STATION HILL READING

AMENDMENTS TO PLANNING PERMISSION REF:
192032/PHASE 2 STATION HILL

JUNE 2023

Changes to the Pocket Park and Planters to the Upper Ground

PROPOSED CHANGES TO LANDSCAPE TO EAST OF ENTRANCE TO OFFICE BLOCK

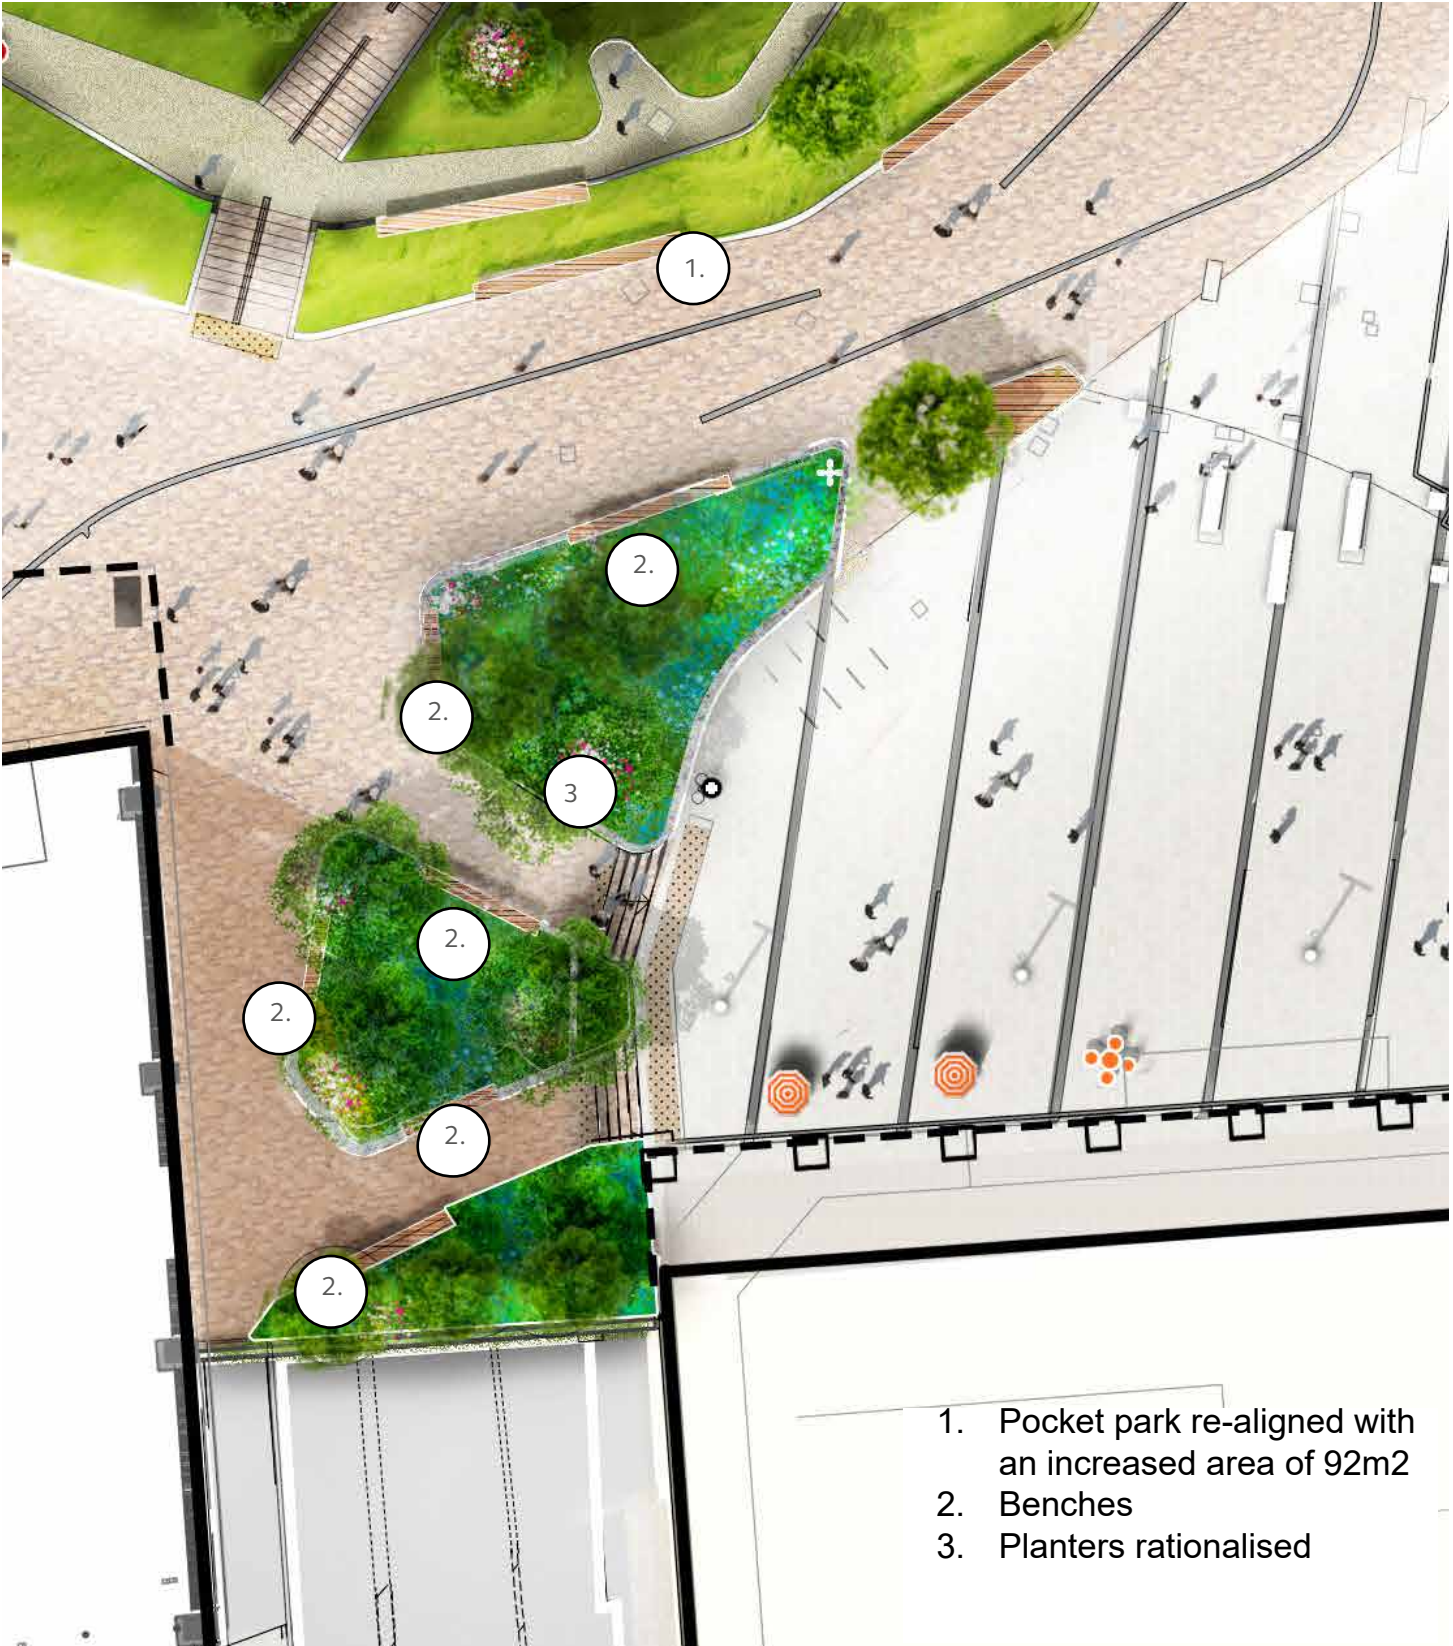
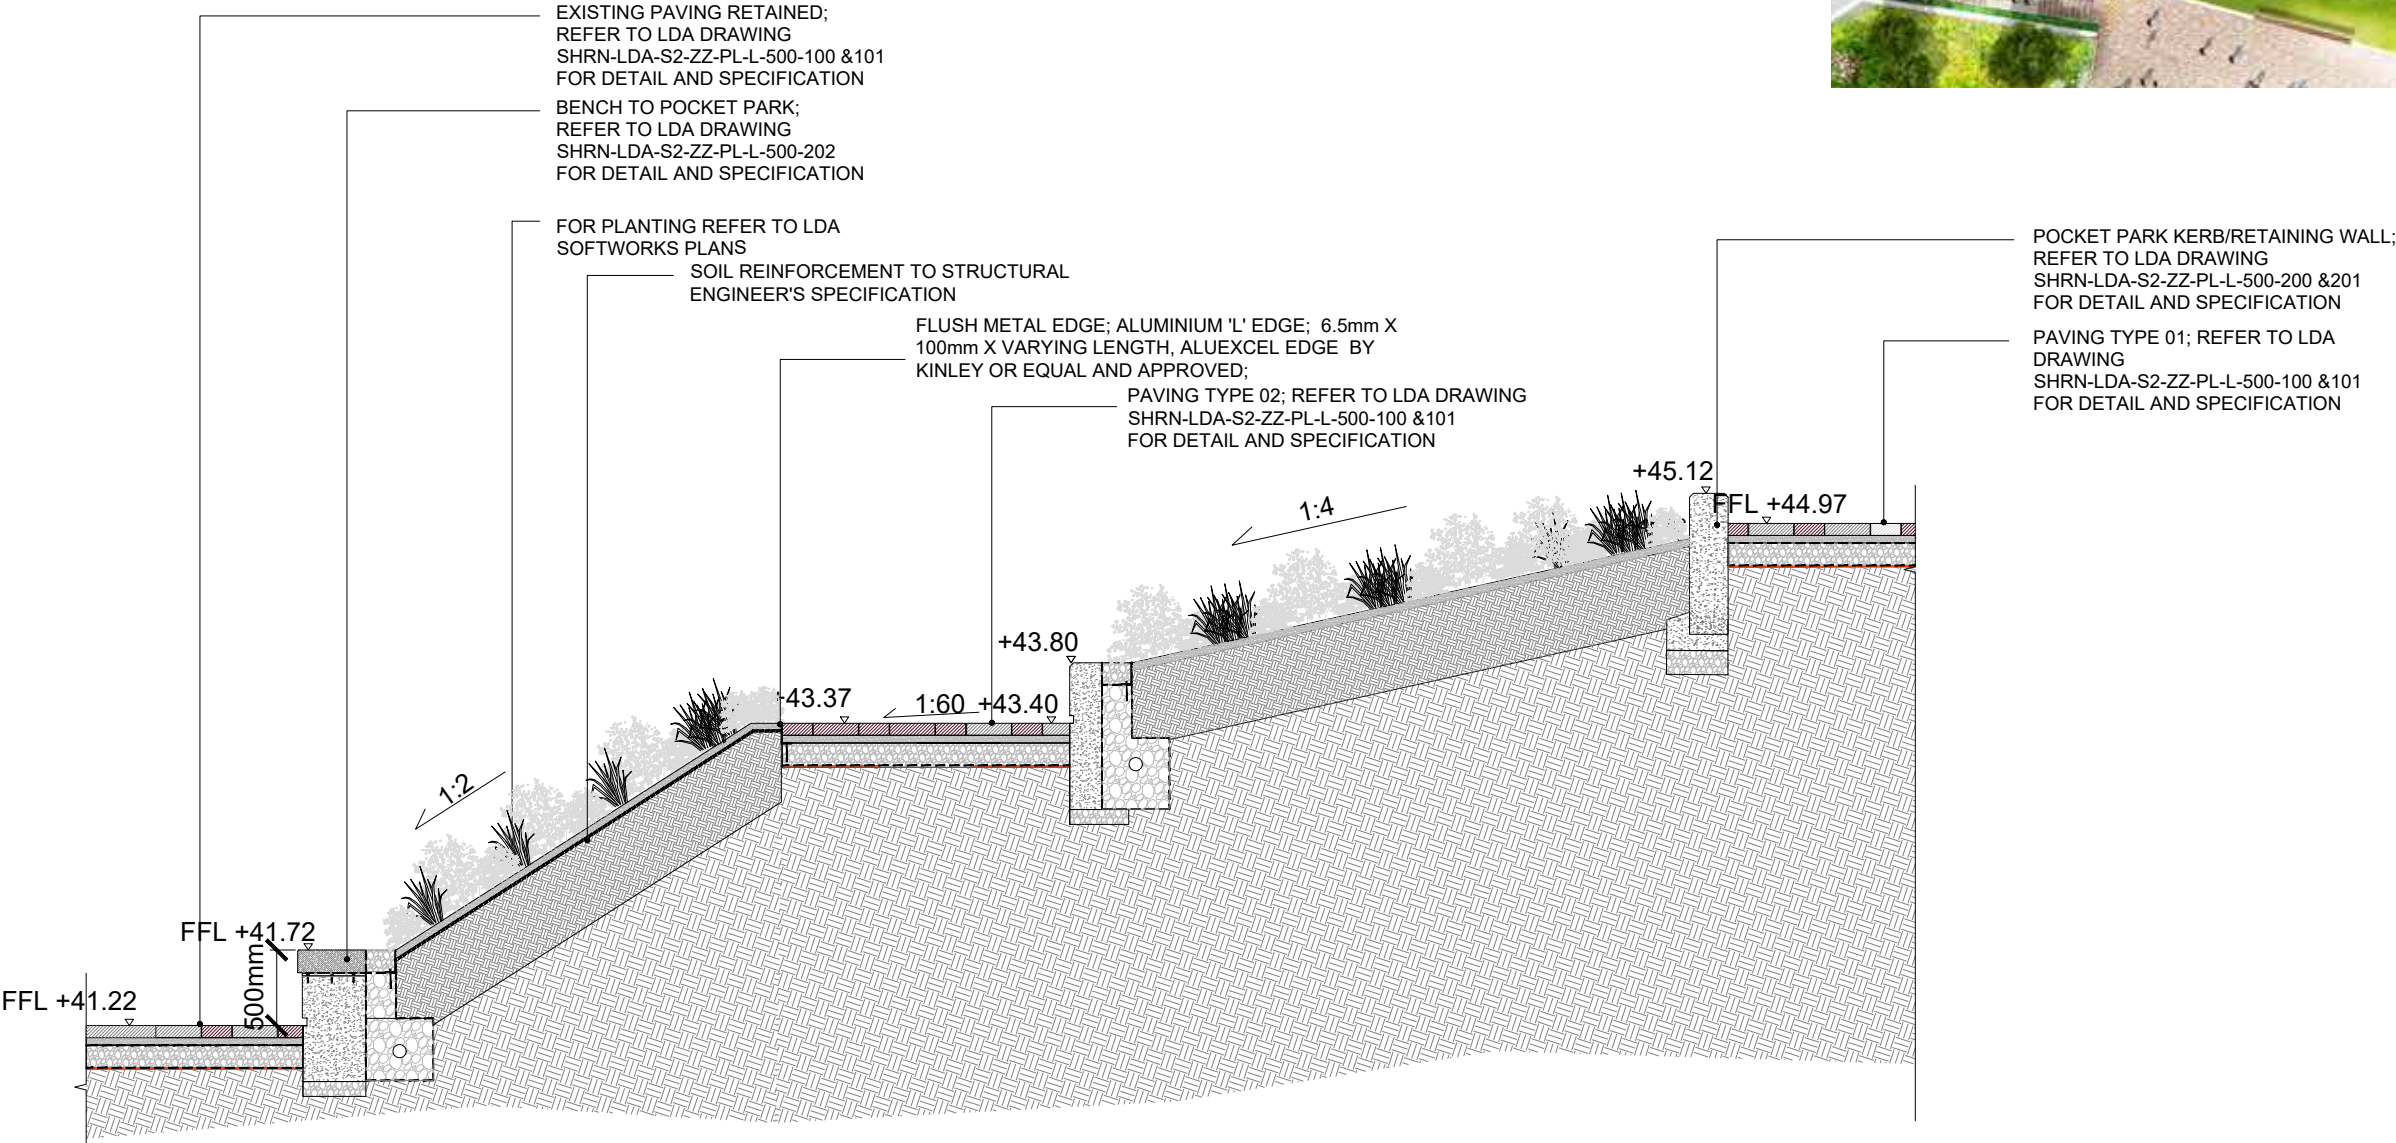
- 1. Pocket park re-aligned with an increased area of 92m2
- 2. Benches
- 3. Planters rationalised

PLANS

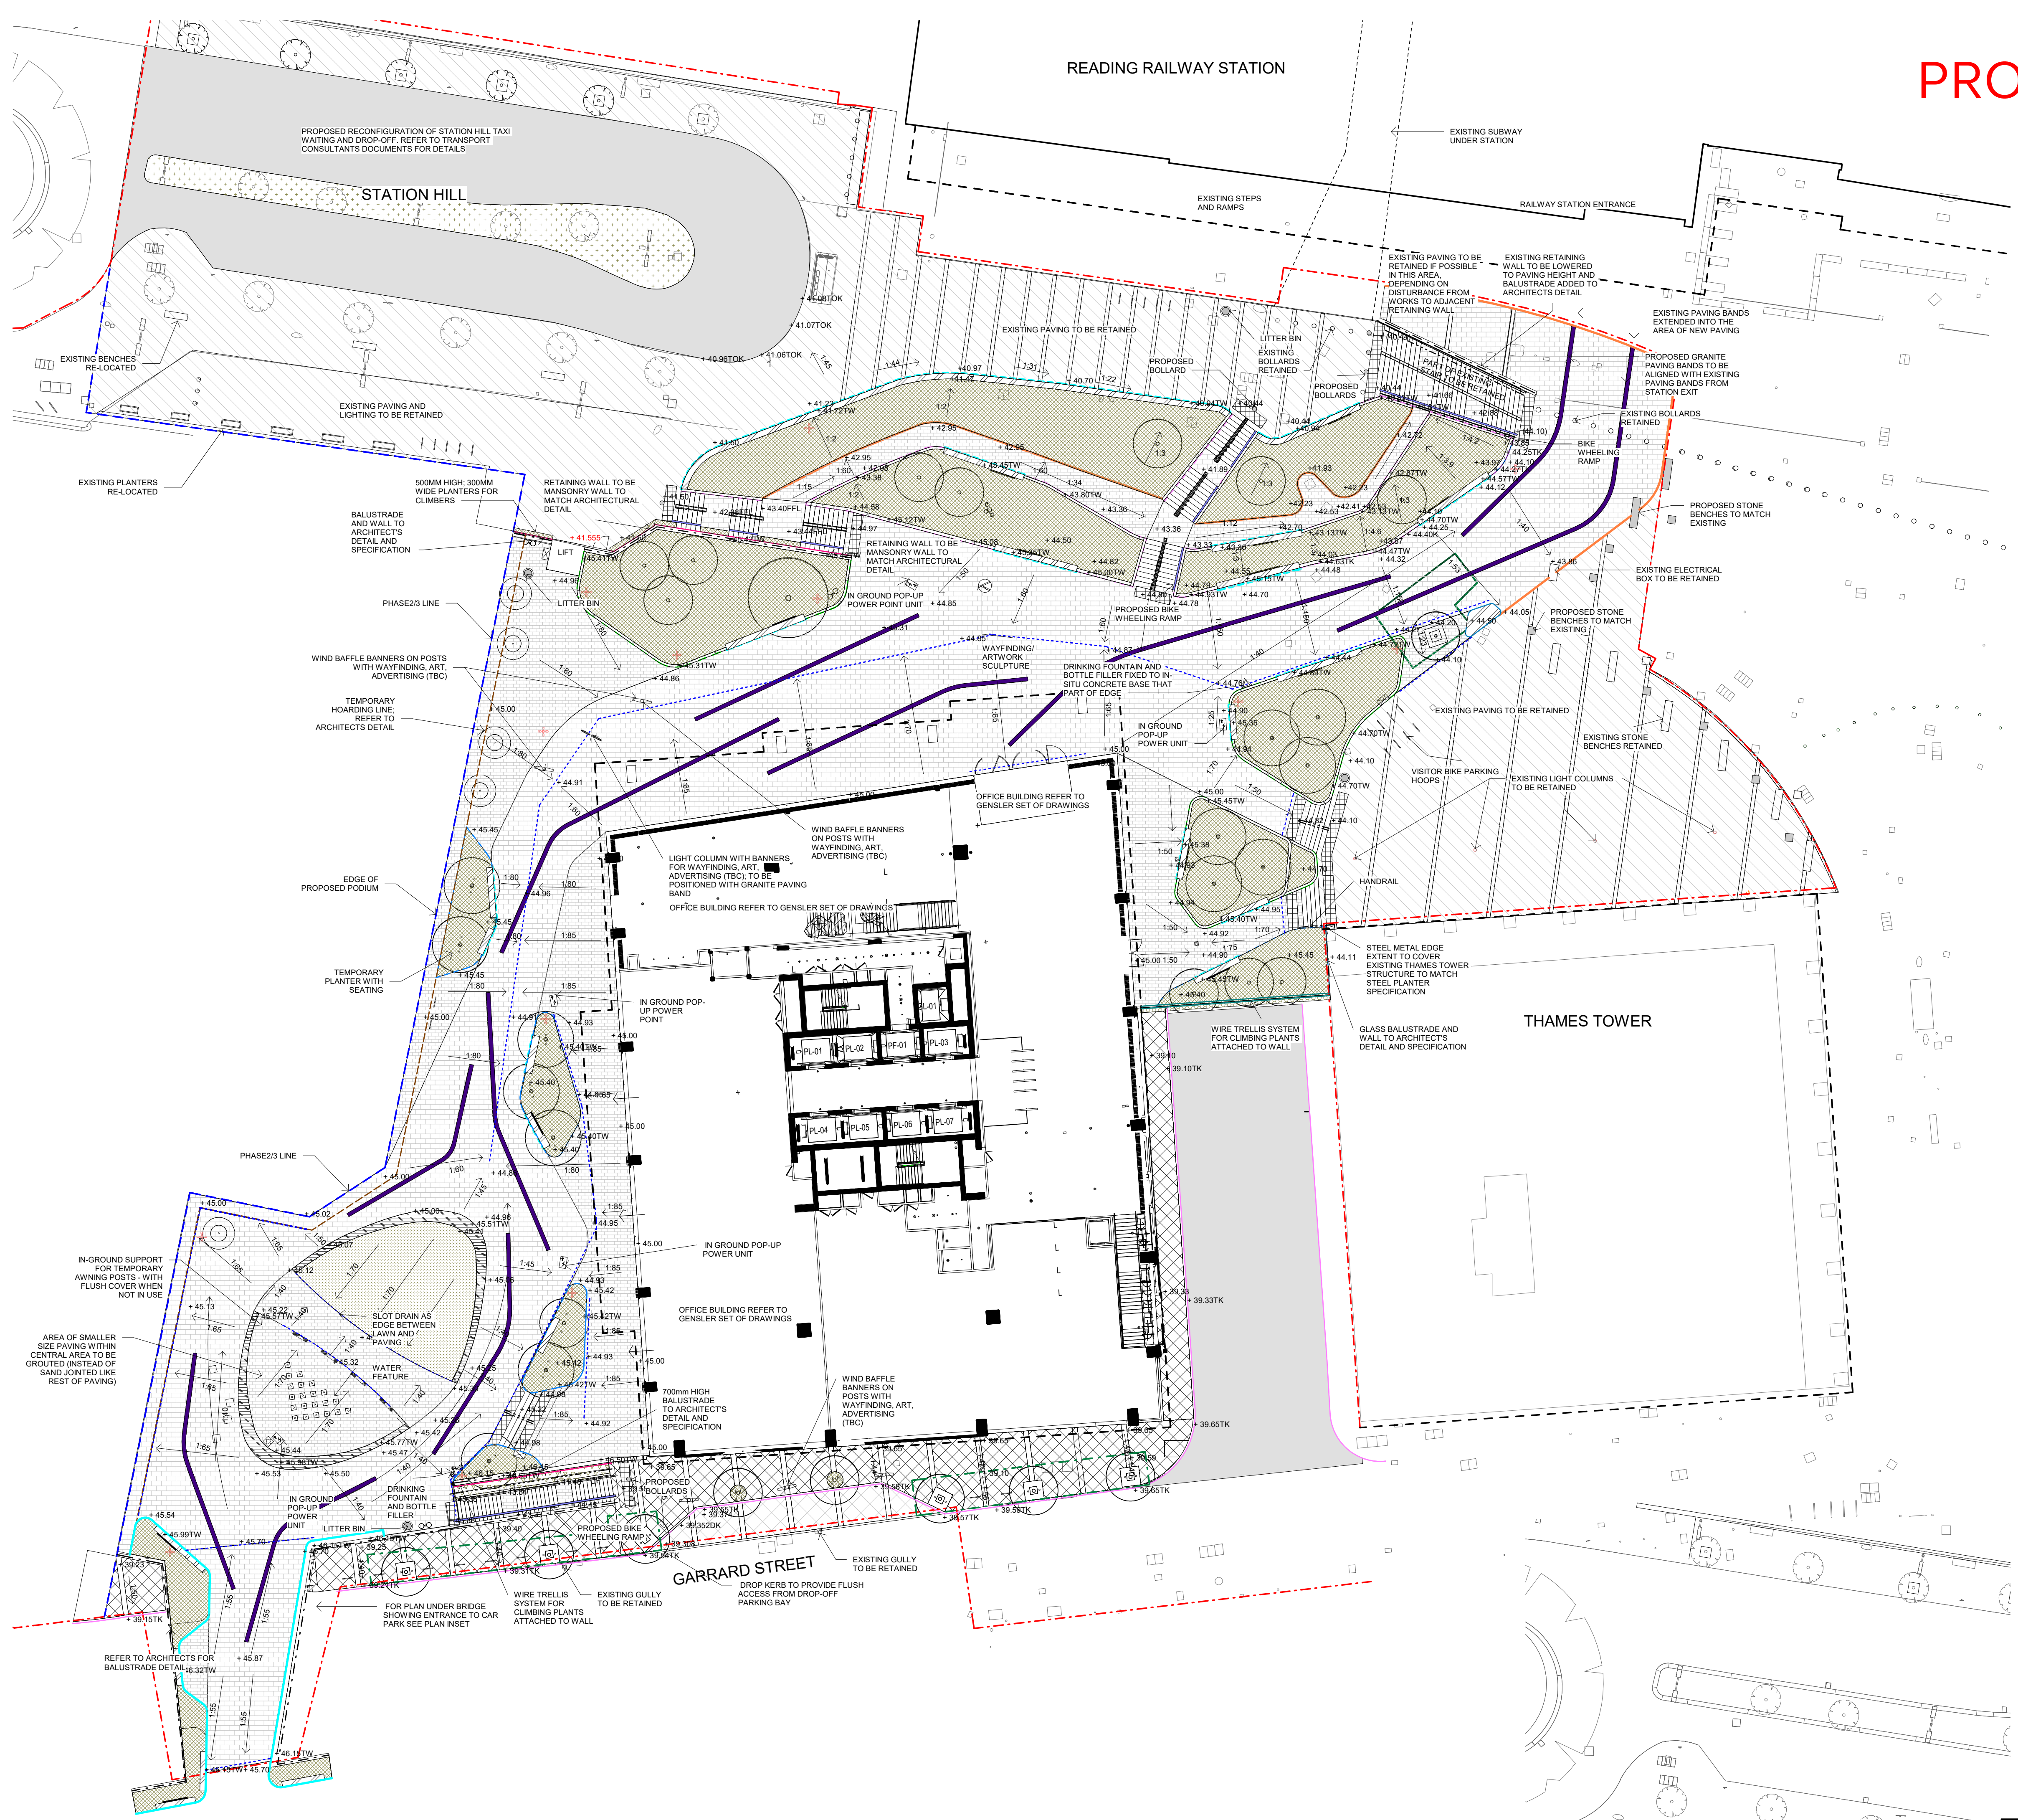
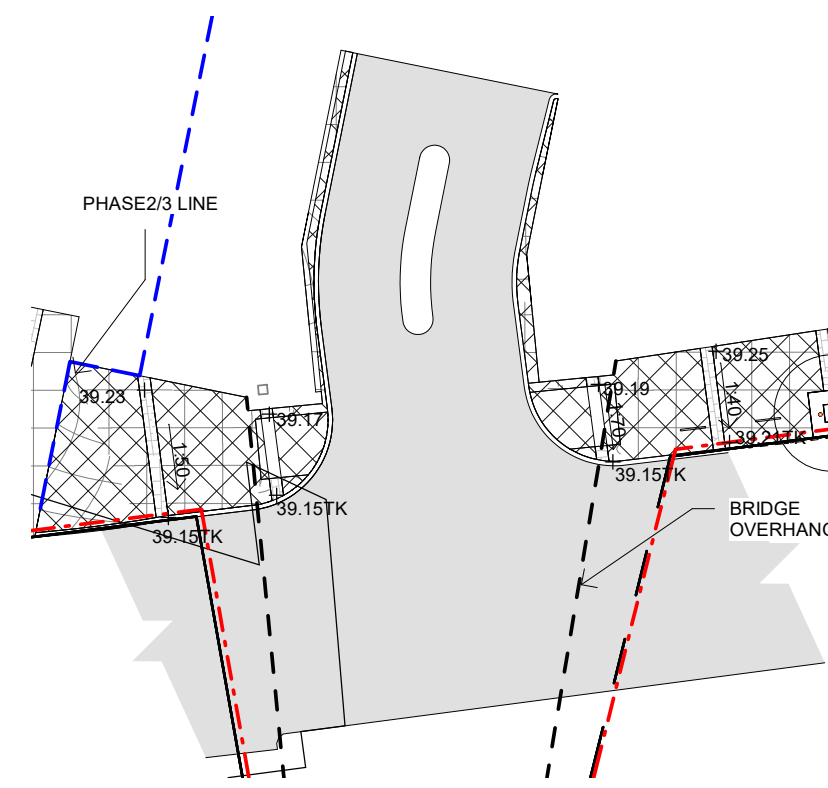
TO10	For Planning	CI	13.06.23
TO9	Water Fountain location update	BB	09.05.23
TO8	Pocket Park Levels Updates	BB	27.04.23
TO7	Issued for S278 works	CI	14.04.23
TO6	Pocket Park Revision	CI	14.03.23
TO5	POCKET PARK REVISION	CI	14.12.22
TO4	POCKET PARK REVISED		06.12.22
